UNITED STATES PATENT AND TRADEMARK OFFICE

Office Action Summary

10/539,161

DETAILED ACTION

Figure 1

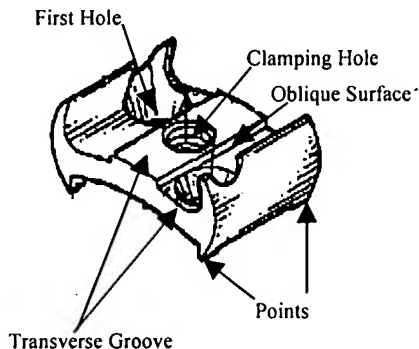
Regarding claims 11, 15, and 16, Shih discloses a device comprising at least one connecting sliding piece (see Figure 1 below). The connecting sliding piece is elongate in a general lengthwise direction and comprises a first hole capable of allow the passage and fixing of an anchoring screw. The connecting sliding piece further comprises receiving means capable of receiving a portion of a fastening rod along a transverse axis perpendicular to the lengthwise direction and to receive clamping

means capable of selectively clamping the fastening rod in the receiving means. The connecting sliding piece further comprises two points capable of penetrating bone to retain the connecting sliding piece on a bone, wherein the two points are disposed in the region of the sliding piece including the receiving means on the interior face of the connecting sliding piece and opposite the receiving means that are on the exterior face of the connecting sliding piece. The two points are parallel to and offset from each other in the direction of the transverse axis parallel to the fastening rod. The fastening rod is engaged in the end of the receiving means opposite the anchoring screw in the general lengthwise direction. Regarding claim 12, Shih discloses a device wherein each point is a generally triangular flat structure in a plane perpendicular to the direction of the transverse axis. Regarding claims 14 and 15, Shih discloses a device wherein the interior face of the sliding connecting piece is capable of bearing against the vertebra and is concave and substantially cylindrical with a circular profile. Further regarding claim 15, Shih discloses a device wherein each point extends in a substantially radial direction of the cylindrical interior face of the connecting sliding piece and the first hole has an axis that is substantially radial relative to the cylindrical interior face of the connecting sliding piece so that the points and the anchoring screw converge toward the vertebra. Further regarding claim 16, Shih discloses a device further comprising a transverse exterior groove, a cylindrical bearing surface, a clamping hole, and an oblique bearing surface. The cylindrical bearing surface forms a first edge of the transverse groove opposite the first hole and conformed to receive a portion of the fastening rod. the clamping hole is located in the bottom of the transverse groove is

separated from the first edge by a distance greater than the diameter of the fastening rod. The oblique bearing surface constitutes a second edge of the transverse groove and is inclined to the axis of the clamping hole.
